BOOTHE SUBDIVISION

APPLICATION NUMBER 4 DATE March 4, 2010

REQUEST Subdivision

DETAIL SITE PLAN

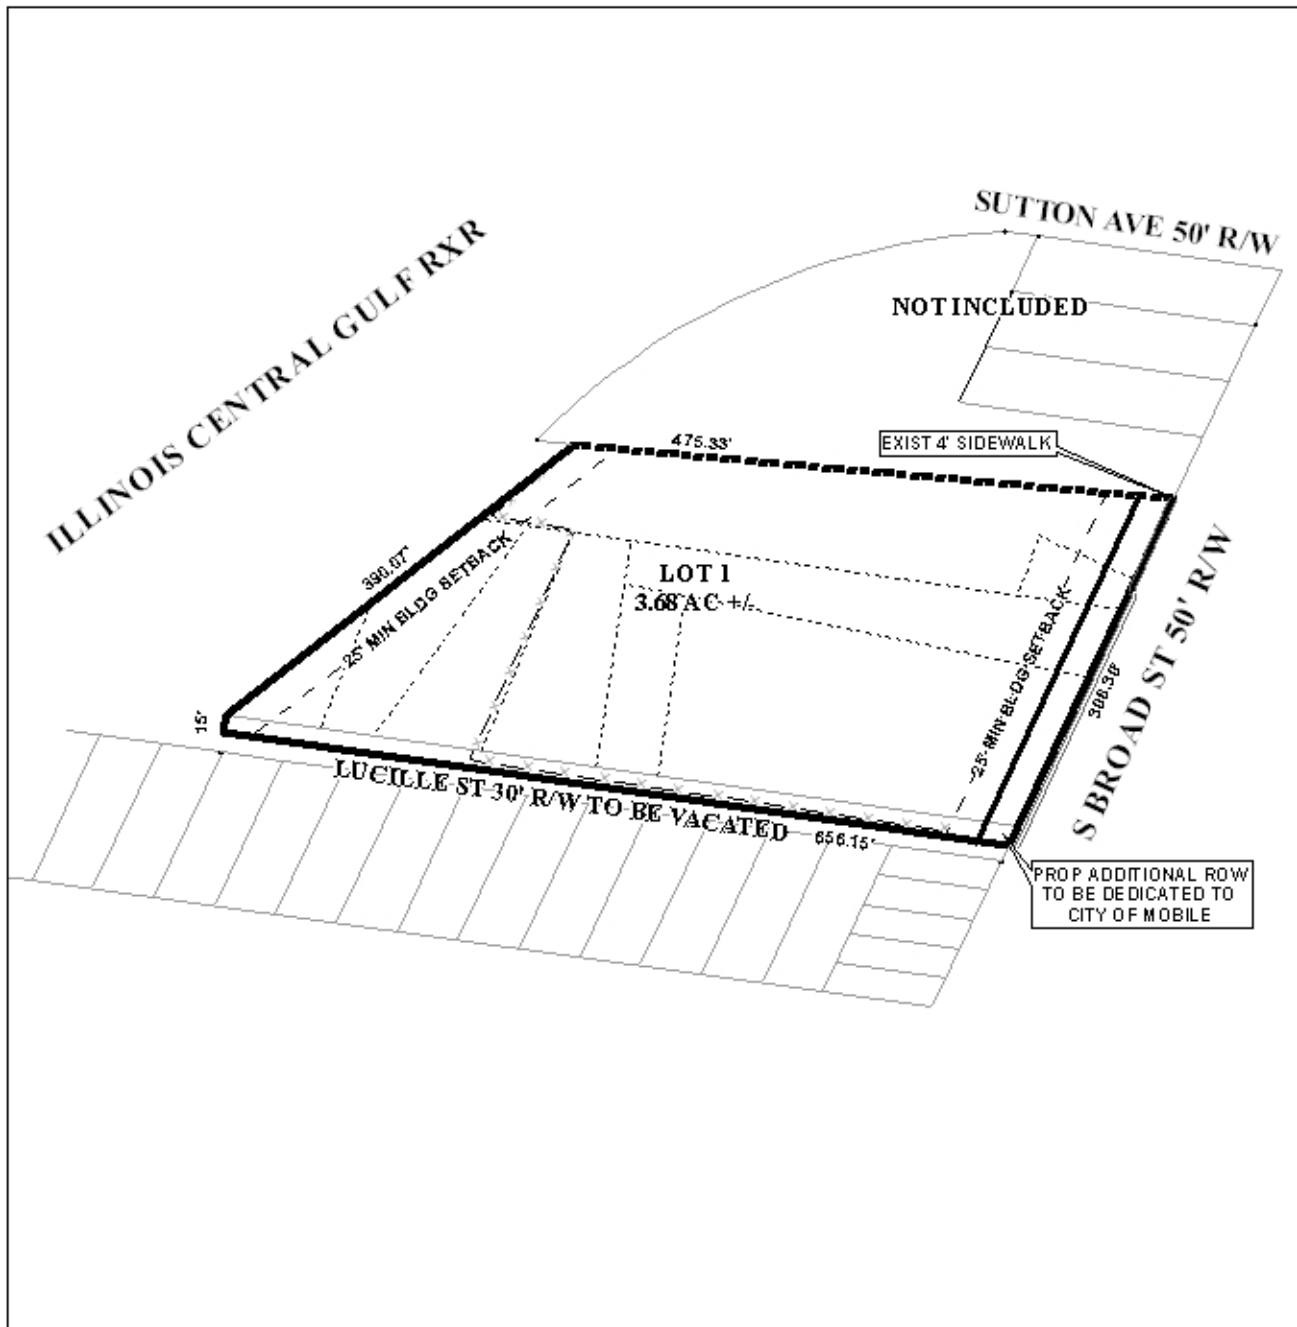
The site fronts on South Broad Street, a proposed major street as shown on the Major Street Plan Component of the Comprehensive Plan, with a proposed 100' right-of-way. As depicted on the preliminary plat, the current right-of-way of South Broad Street is 50', and an additional 25' are depicted to be dedicated to provide 50' from the centerline of South Broad Street. This dedication should be required on the Final Plat. Also depicted is the proposed vacation of Lucille Street, an unopened 30' right-of-way along the South side of the subject site. As proposed, the site would obtain the North 15' after the vacation; therefore, the Vacation Process for Lucille Street should be completed and recorded before signing of the Final Plat. As illustrated on the preliminary plat, the 25' minimum building setback line along South Broad Street should be indicated as measured from the required frontage dedication, and the setback along the rear should be illustrated as measured from the existing Canadian Northern Railroad right-of-way.

As South Broad Street is a proposed major street, access management is a concern. The site is developed and aerial photographs indicate three access points to the property from South Broad Street. One is at the North end of the site, one is in the middle of the site, and one is via the unopened portion of Lucille Street at the South end of the site. As the site appears to have a wrap-around drive for truck access to the existing building, two curb cuts would be in order to provide truck access and front parking lot access. Therefore, the lot should be limited to two curb cuts, with the size, location and design to be approved by Traffic Engineering and conform to AASHTO standards.

The lot on the preliminary plat is labeled with its size in square feet and acres, and should also be so-labeled on the Final Plat, or a table should be furnished providing the same information.

- 1) dedication of sufficient right-of-way to provide 50' from the centerline of South Broad Street;
- 2) completion of the Vacation process for Lucille Street and the recording of such prior to signing the Final Plat;

- 3) illustration of the 25' minimum building setback line along South Broad Street as measured from any required dedication;
- 4) illustration of the 25' minimum building setback line along the Illinois Central Gulf Railroad right-of-way as measured from the current right-of-way line;

- 5) placement of a note on the Final Plat stating that the subdivision is limited to two curb cuts to South Broad Street, with the size, location and design to be approved by Traffic Engineering and conform to AASHTO standards;

- 6) labeling of the lot with its size in square feet and acres, after the Lucille Street vacation and any required dedication, or the furnishing of a table on the Final Plat providing the same information;
